Government {1905} of Madras.
EDUCATIONAL.

G.O., No. 286, 4th May 1905.

Victoria Memorial building.

Informing, with remarks, the Committee of the Victoria Technical Institute that it will be allowed to occupy the eastern half of the Marlborough house site adjoining the compound of the Government Museum for the purpose of the —.

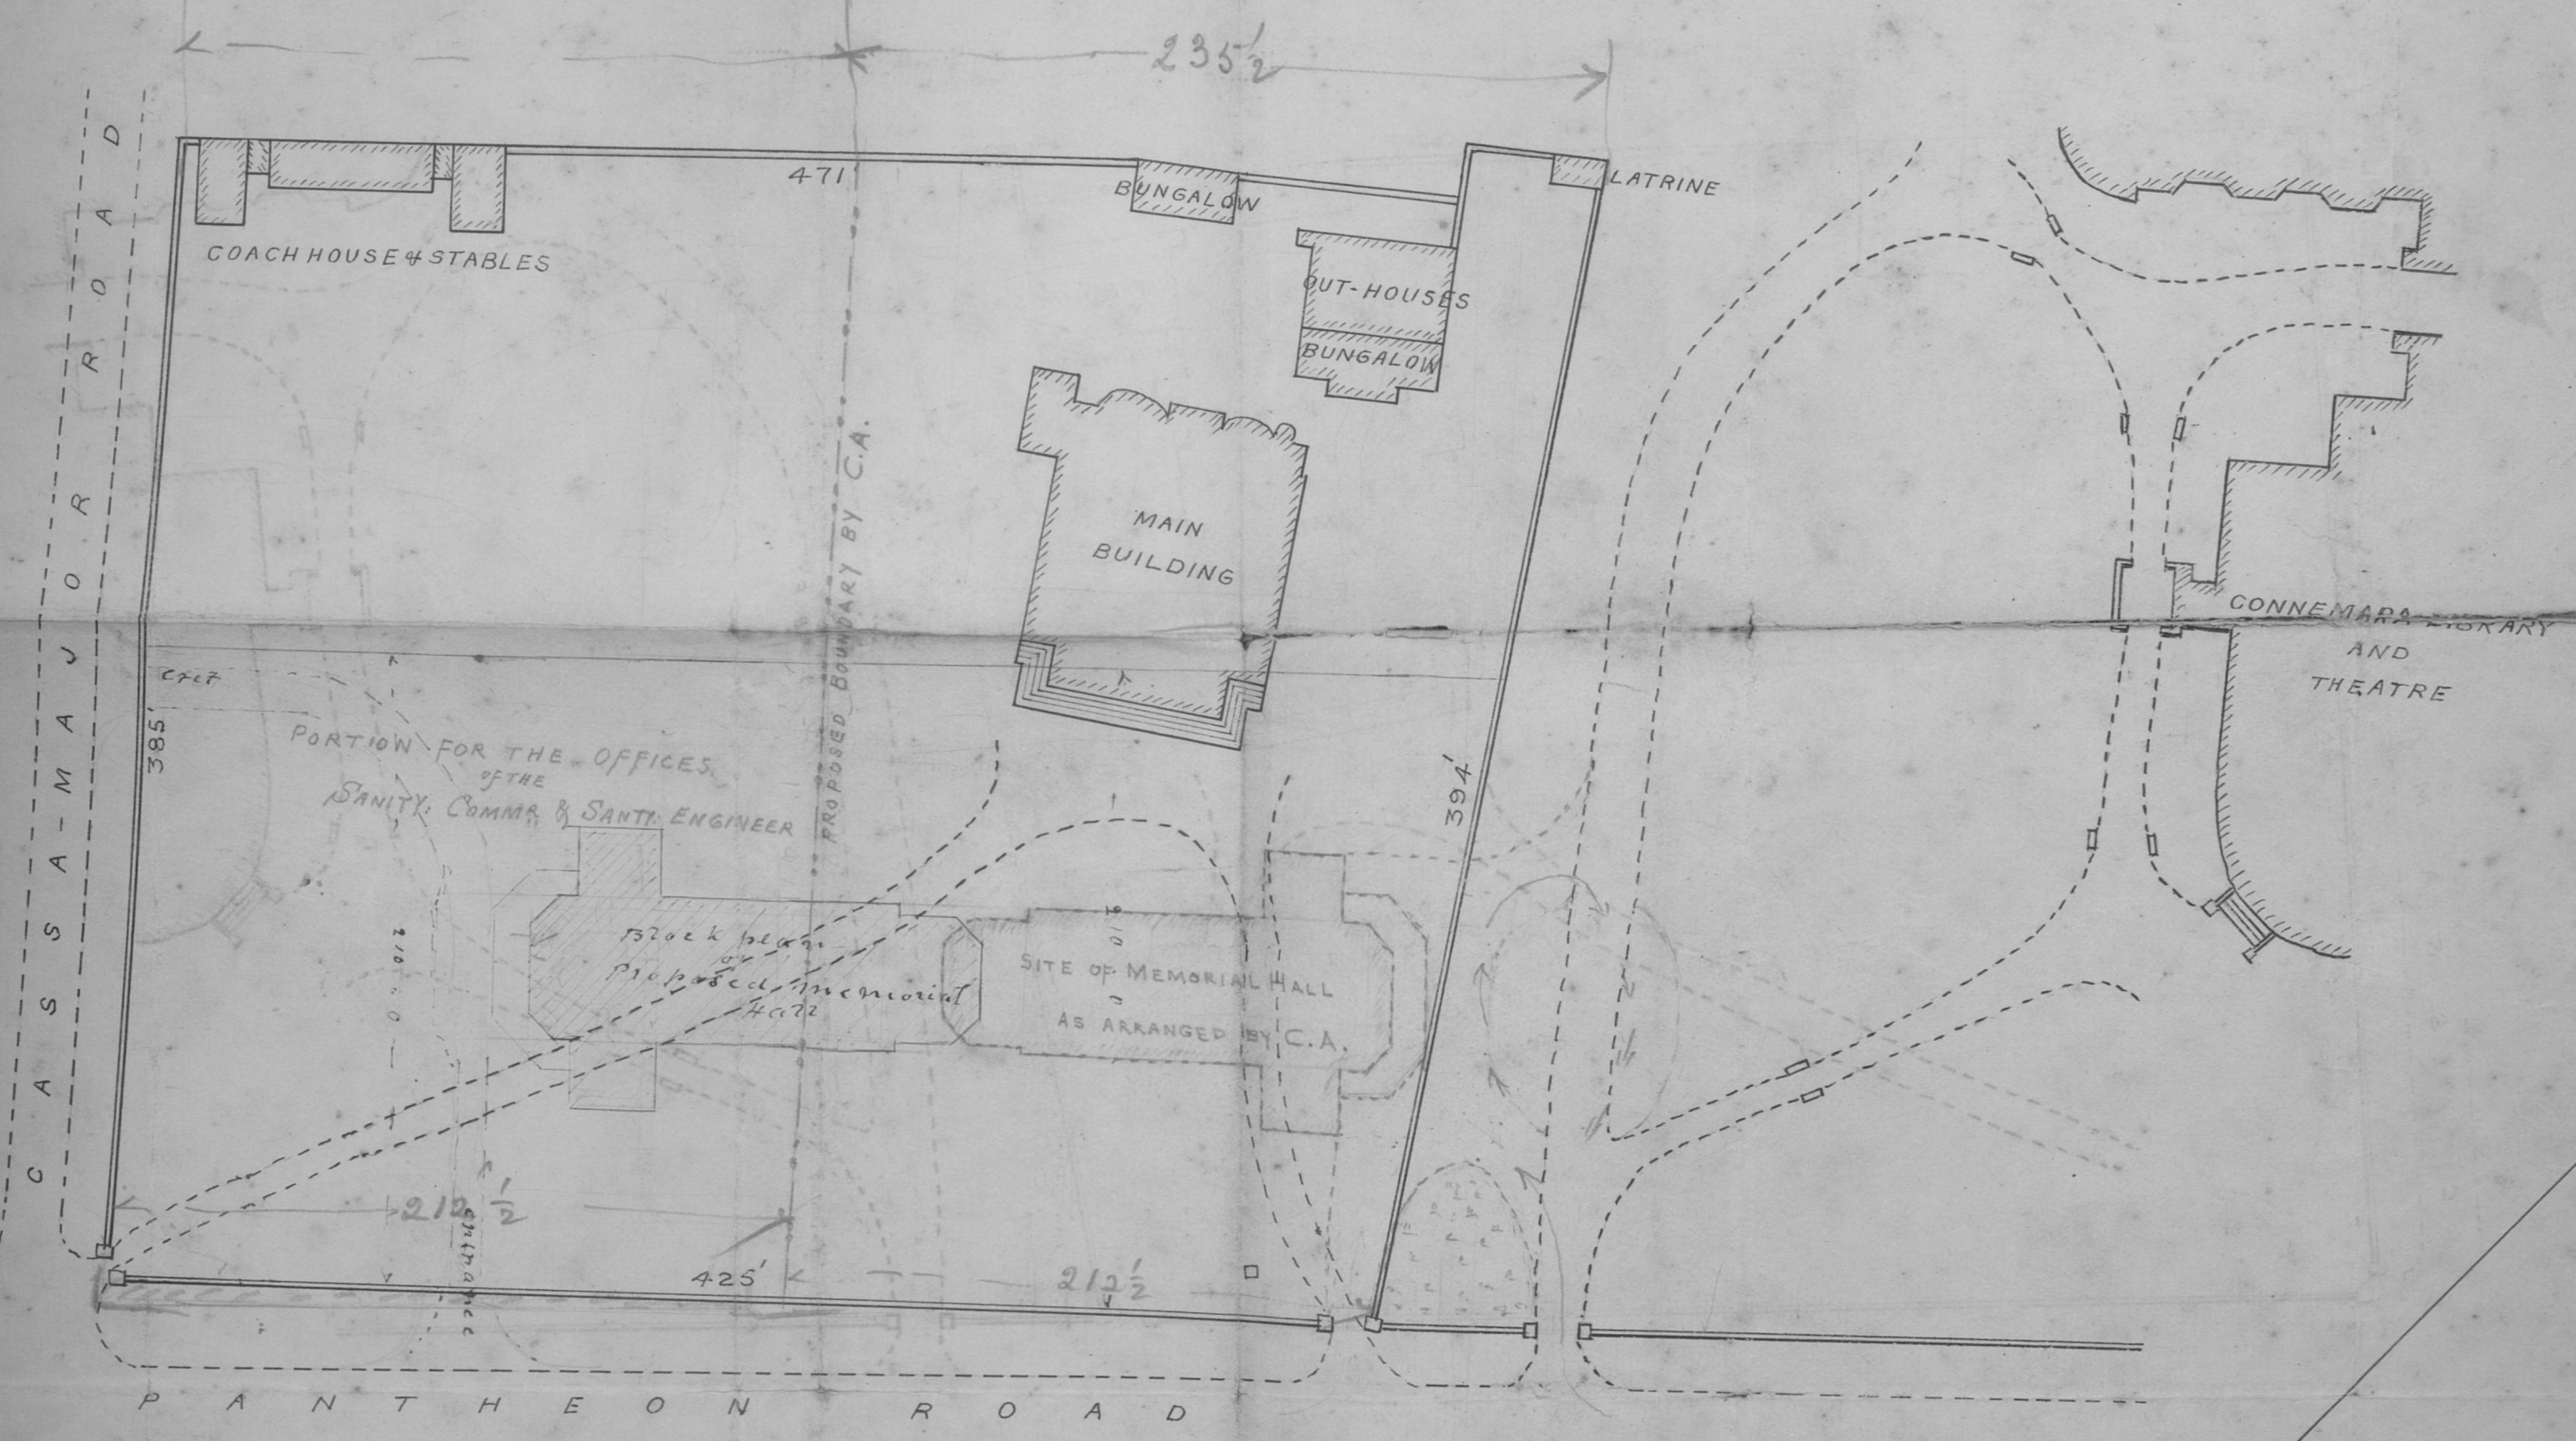
With reference to your memorandum No. 615, dated 23rd November 1904, I have the honour to state, that if the line drawn across and figure-spaced at 210 feet on the plan, indicates the boundary demanded by the Council, the demand is considerably more than half the total area.

The strip left is of no use. The offices for the Sanitary Commissioner and Sanitary Engineer could not be arranged therein in any possible fashion.

Even if the compound is divided in exactly half, on the long length, the half left would be of no use.

If divided the other way it could be utilized, and I have dotted in on the plan in pencil how I would propose to arrange the Memorial Hall, utilizing the existing south-east gate of the Museum.

The two positions of the building are shown in the plan.

The Committee of the Victoria Technical Institute will be allowed to occupy the eastern half of the Marlborough house site adjoining the compound of the Government Museum for the purpose of their building, which will face Pantheon Road. The road frontage of the area so occupied will be $212\frac{1}{2}$ feet, and the rear length $235\frac{1}{2}$ feet. The remaining or western half will be reserved for the purposes of Government.
